# LONDON BOROUGH OF ENFIELD

## PLANNING COMMITTEE

**Application Number :** TP/10/0601

**LOCATION:** MAIN BUILDING, ST MICHAELS C OF E PRIMARY SCHOOL,  
BRIGADIER HILL, ENFIELD, EN2 0NB

PROJECT: ST MICHAEL'S CE PRIMARY SCHOOL  
 DRAWING TITLE: GROUND FLOOR PLAN  
 PROPOSED  
 DATE: MARCH 2010  
 SCALE: 1:100 @ A1  
 JOB NO: RX-2687  
 2002

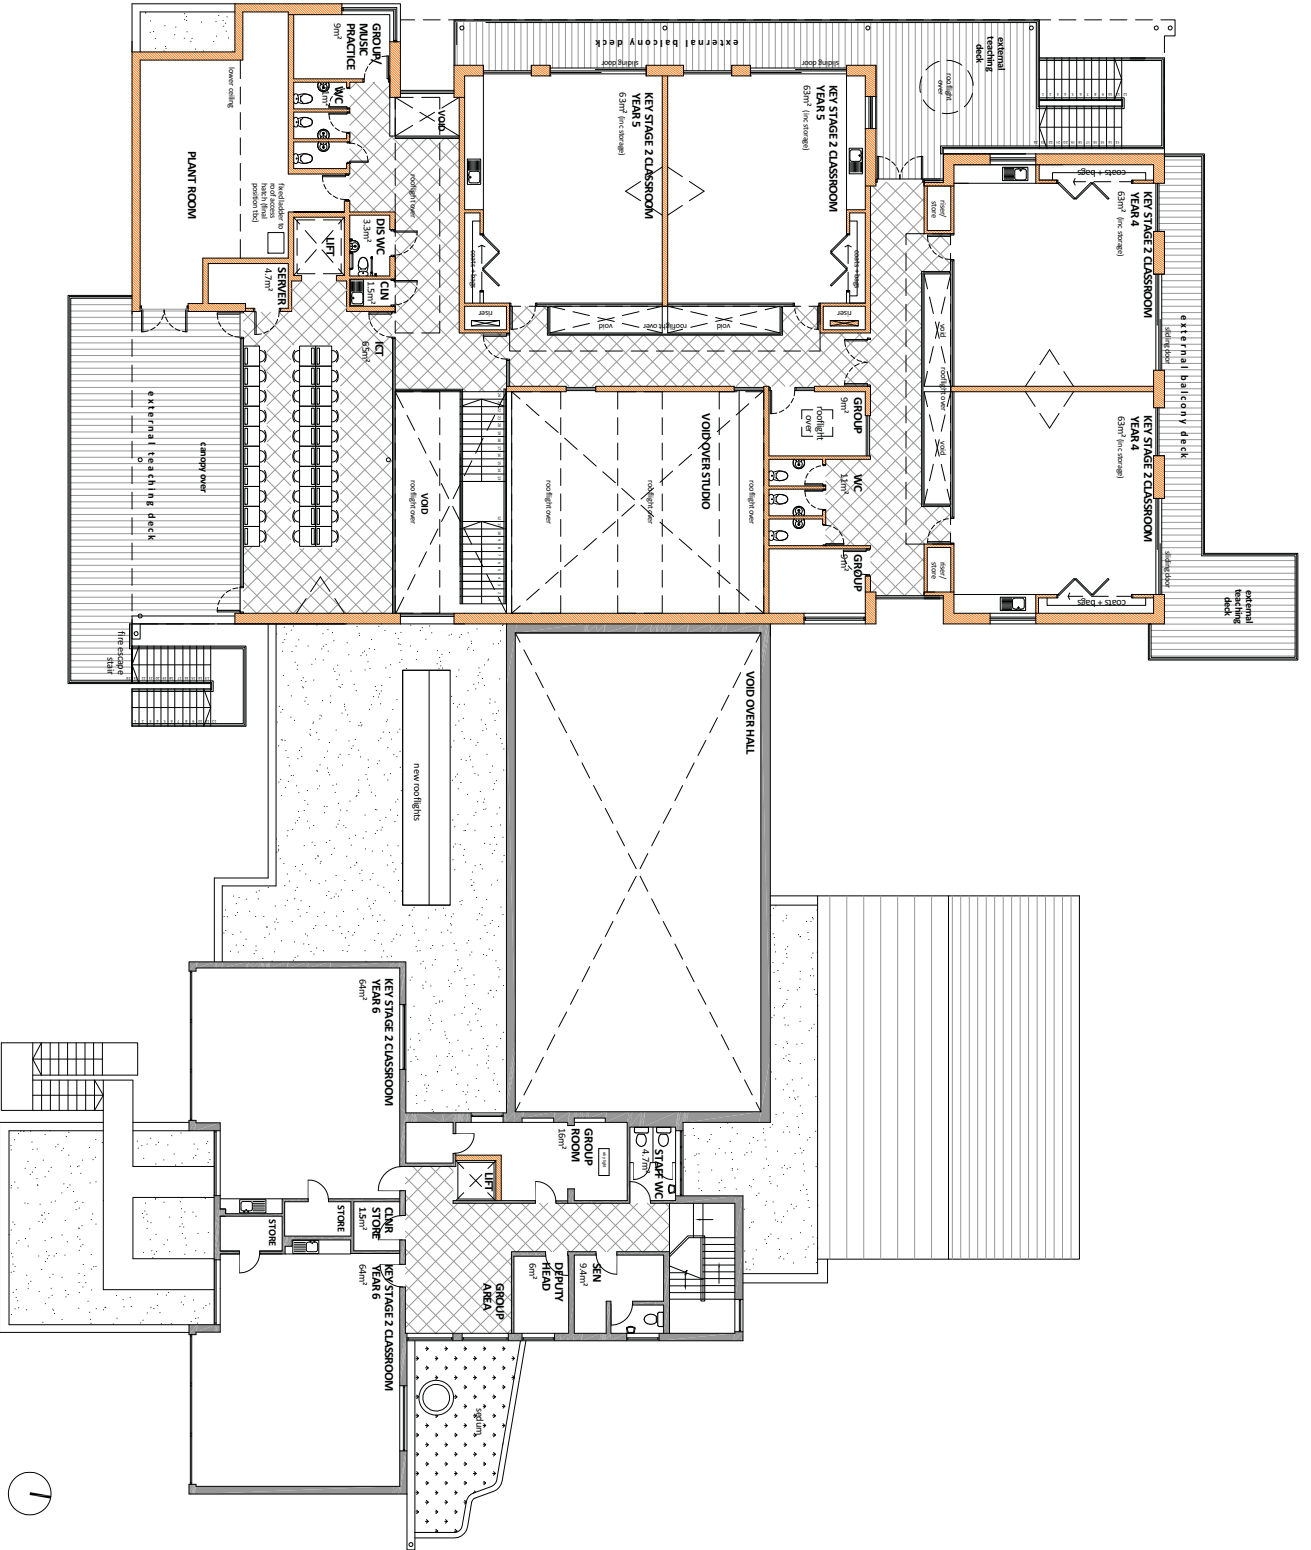
1. C07 Details of Materials
  2. C09 Details of Hard Surfacing
  3. C10 Details of Levels
  4. C11 Details of Enclosure
  5. C12 Parking and Turning Facilities  
Parking and turning facilities shall be provided in accordance with Drawing No.2002 unless otherwise approved in writing by the Local Planning Authority.  
Reason: To ensure the development complies with adopted standards and does not prejudice conditions of safety or traffic flow on the adjoining highway.
